**MONTGOMERY COUNTY HISTORIC PRESERVATION COMMISSION**  
**STAFF REPORT**

<b>Address:</b>	51 Walnut Avenue, Takoma Park	<b>Meeting Date:</b>	9/17/2025
<b>Resource:</b>	Contributing Resource Takoma Park Historic District	<b>Report Date:</b>	9/10/2025
<b>Applicant:</b>	Jeffrey Hopkins & Rebecca Smith	<b>Public Notice:</b>	9/3/2025
<b>Review:</b>	HAWP	<b>Tax Credit:</b>	n/a
<b>Permit Number:</b>	1130761	<b>Staff:</b>	Dan Bruechert
<b>Proposal:</b>	HVAC Unit.

The applicant proposes to add an exterior HVAC unit, exterior conduit, and penetrate the wall and the newly constructed dormer.

Figure 2: Approximate location for the outdoor condenser and conduit.

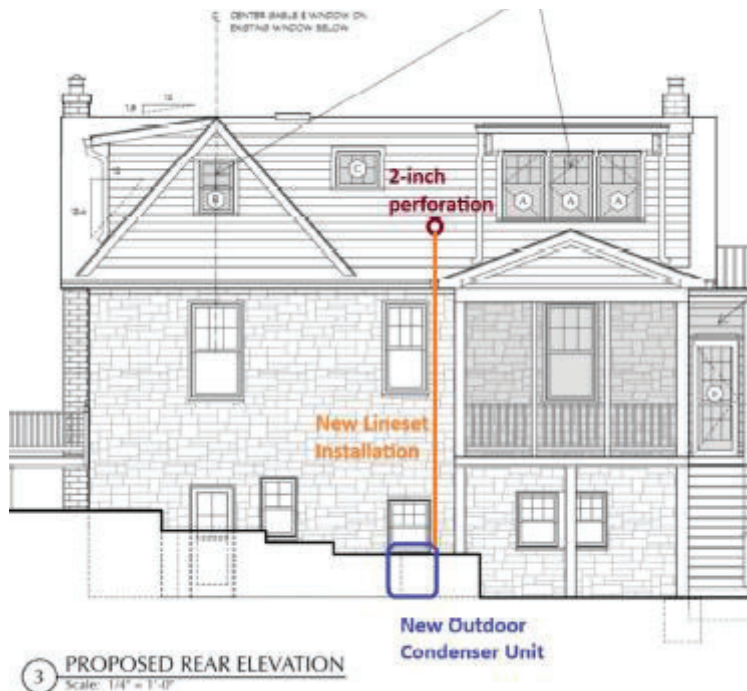
The subject property is a one-and-a-half-story side-gabled bungalow covered in Formstone. In 2024, the HPC approved a rear addition on the second story. The addition is currently under construction (see the supplied application photographs.) The applicants propose to add an additional mini-split unit to service the second-floor addition. A conduit will run from the HVAC unit along the rear wall and penetrate the addition's wall through a 2" (two inch) hole. The condenser will be located off of the rear wall, adjacent to the new rear porch, 26' (twenty-six feet) from the property line at Eastern Ave. The proposed unit measures 31" × 21" × 13" (thirty-one inches long by twenty one inches tall by thirteen inches wide)

Staff recommends that the Commission **approve** the HAWP; under the Criteria for Issuance in Chapter 24A-8(b)(1), (2), and (d), having found that the proposal, as modified by the condition, is consistent with the *Takoma Park Historic District Guidelines* and the purposes of Chapter 24A;
